## Model Error Resolution Document

1. Originator: John Case/Ernest Hardin	2. Date: 07/11/2008	3. ERD No. ANL-NBS-HS-000057 ERD 02
---	------------------------	--

4. Document Identifier: ANL-NBS-HS-000057 REV 00	5. Document Title: Postclosure Analysis of the Range of Design Thermal Loadings
---	--

6. Description of and Justification for Change (Identify applicable CRs and TBVs):

Figure 6.2-13 Mid-Pillar Temperature for a Line-Source Solution, Using the Postclosure Reference Thermal Load and Varying Host-Rock Thermal Conductivity

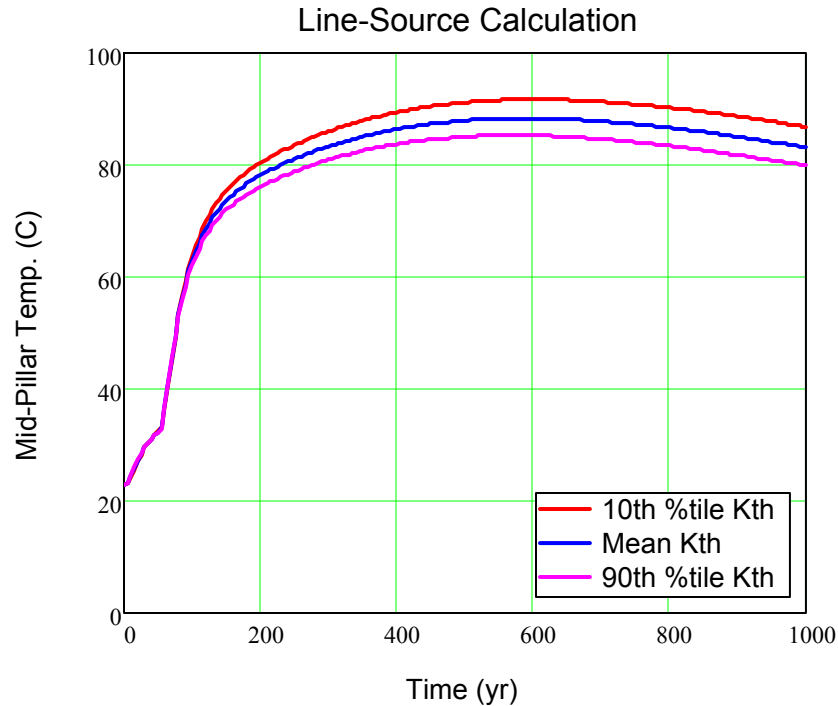
**II.2** (Fig. 6.2-13 and output DTN MO0705SUPPCALC.000). This figure is reasonable but cannot be traced to the Mathcad file indicated as the source. A revised Mathcad file is provided (filename: *WPIMP vs. Kth (corrected) August 2008.xmcd*) containing a traceable plot for 50-yr ventilation, 86% efficiency, host rock saturation 100%, and neglecting the effect of lithophysal porosity on the (volumetric) heat capacitance. The DTN is revised to include the corrected file.

Figure 6.2-13 and its accompanying notes are revised as follows:

Source: Output DTN: MO0705SUPPCALC.000, Directory: Other Supporting Files, File: *WPIMP vs. Kth (corrected) August 2008.xmcd*.

NOTES: The 10<sup>th</sup> percentile, mean, and 90<sup>th</sup> percentile values for wet thermal conductivity of the lower lithophysal (Tptpl) host unit are 1.69, 1.87, and 2.06 W/m-K, respectively. Calculated using a ventilation duration of 50 years, preclosure ventilation heat removal efficiency of 86%, and neglecting the effect from lithophysal porosity on heat capacitance.
